BZA-1712
MANUEL AND AGUEDA GAETA
Variance

STAFF REPORT
May 18, 2006

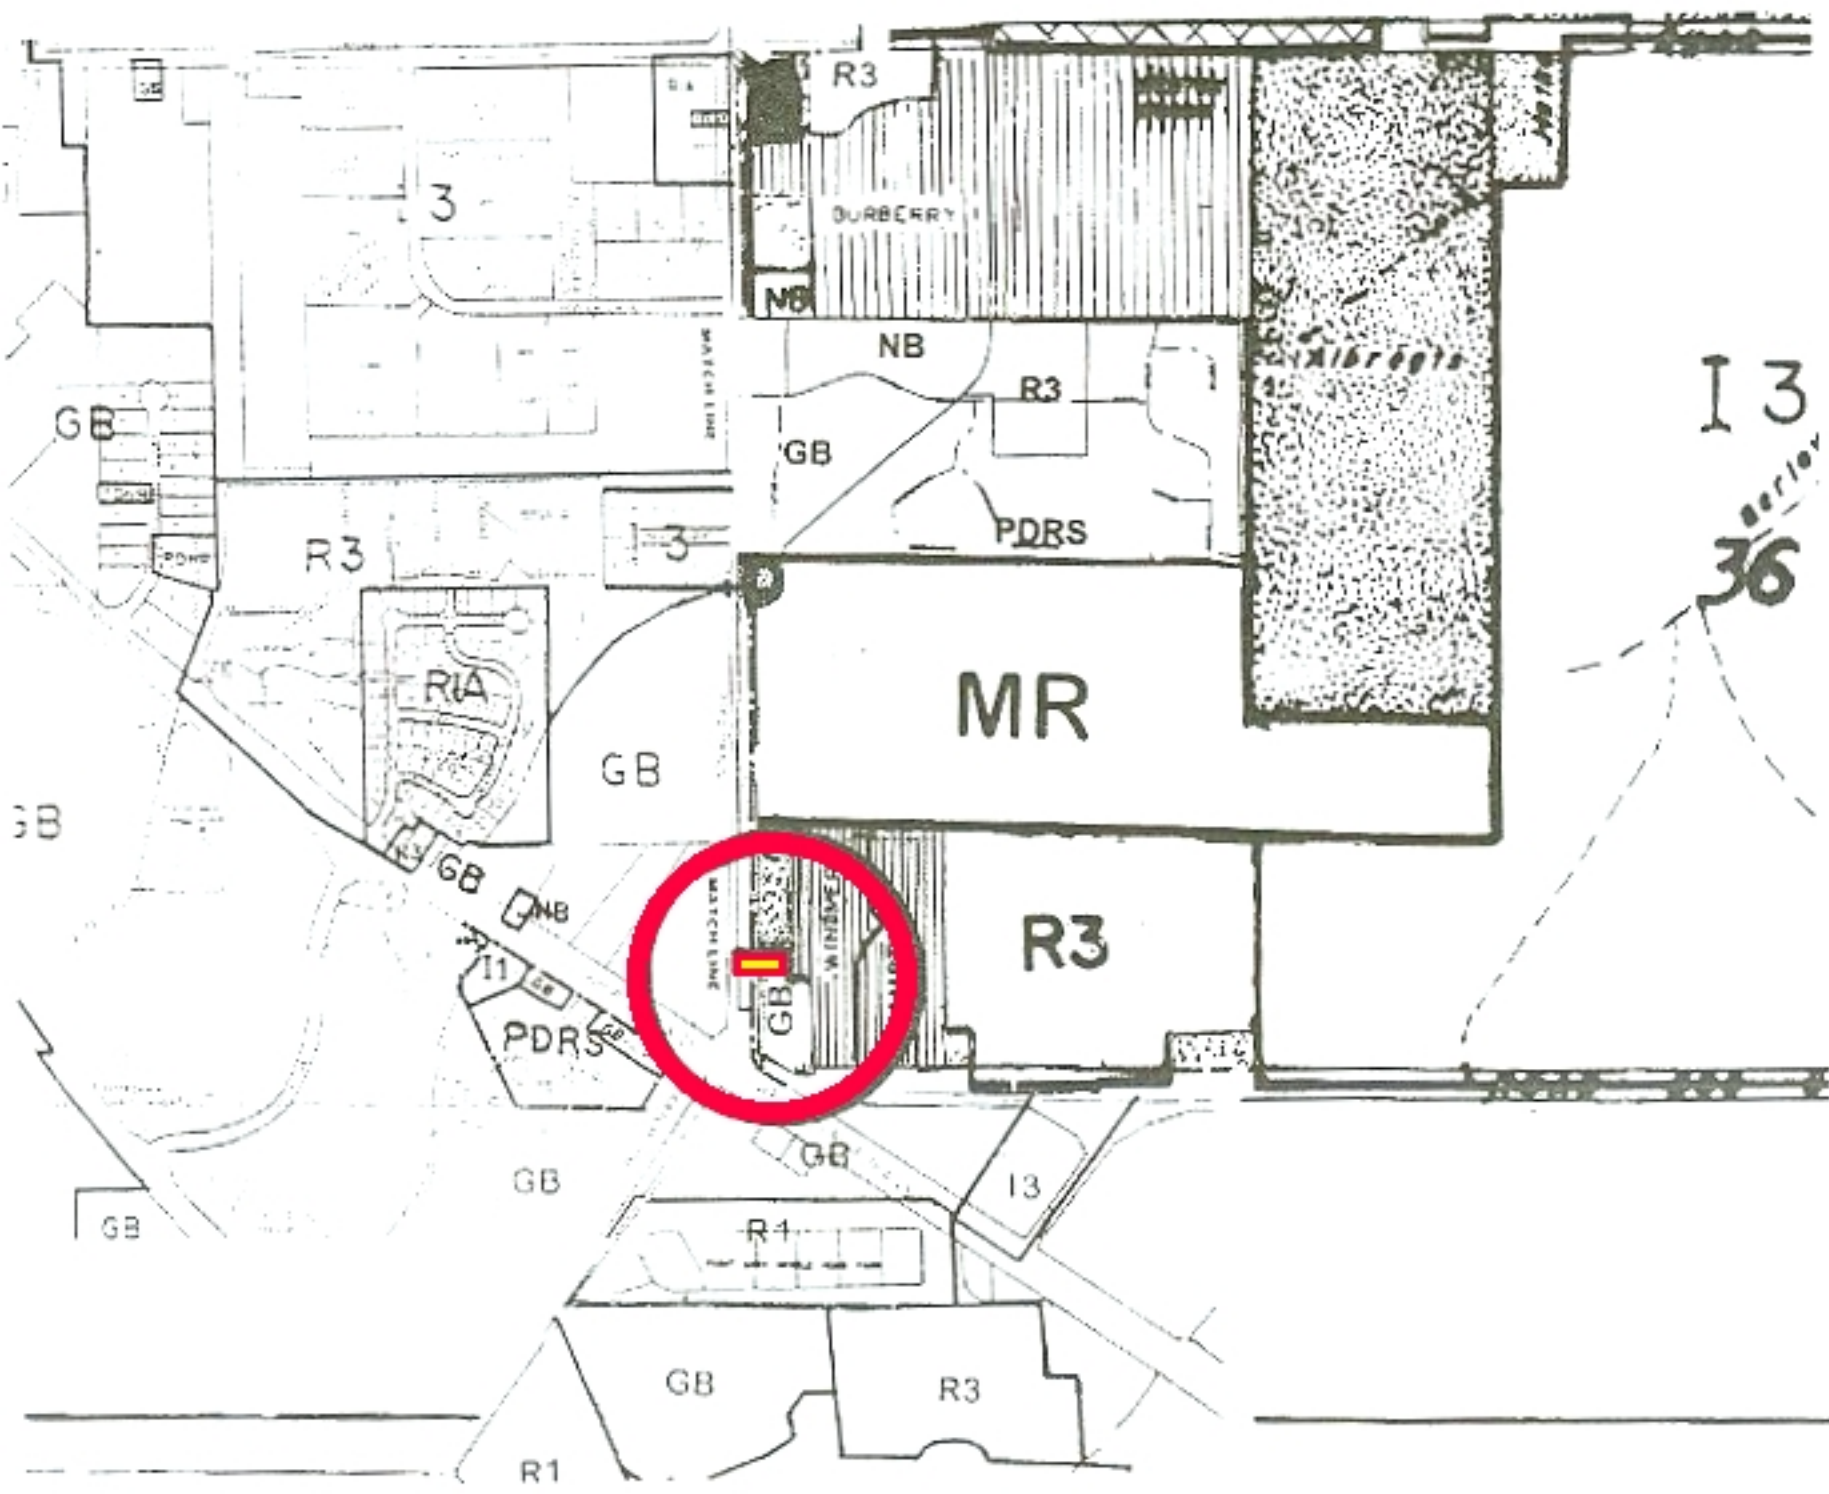
How the traffic flow will be managed on site is not entirely clear based on the site plan

submitted. The proposed building will have garage doors to the rear, and the proposed driveway leading to these doors is the reason for the reduction in the rear bufferyard. Staff does not know if the existing residential driveway will be utilized for the business or not. Either way a commercial drive permit will be required.

A Type C bufferyard measuring 20' wide with 4 standard plant units is required where GB zoning abuts residential zoning on the northern and eastern property line. The site plan shows this Type C bufferyard using the plant units in Alternative 1. While the exact plant list has not been shown, Alternative 1 consists of one 3" caliper canopy tree, two 1 ½" caliper under-story trees and ten 3' high shrubs per 150' of linear length.

The site plan submitted does not show the required 5' no-parking setback, the driveway location, or the area petitioners' intend to pave. A revised site plan showing these items will be a condition of these requests.

Petitioners would like to locate their building 5' from the northern (side) lot line, instead of the required 30'. The petition states that the area that once contained a swimming pool is unstable for a building site and prevents them from building there. While this land may require fill and compaction, it could still be stabilized enough to support a building. In fact, the site plan indicates a driveway will be located on top of the former pool site. Fill and compaction for the driveway would be just as necessary as for a building.

The two requests for reduced bufferyards are only necessary because of the proposed location of the building in the rear and side setbacks. One possible solution would be to place the building directly west of the former pool site where the permitted side setback is 0'. This would allow for the driveway to access the building without reducing the eastern bufferyard. While this may reduce the area available in the front of the lot used to show cars, it protects the existing residence to the north and allows for the required bufferyards to function as they were intended.

1. A new site plan showing the 5' no-parking setback, driveway and paved area locations;
2. a copy of the commercial drive permit from the City of Lafayette; and
3. some indication from the County Surveyor that Drainage Board approval has been received.
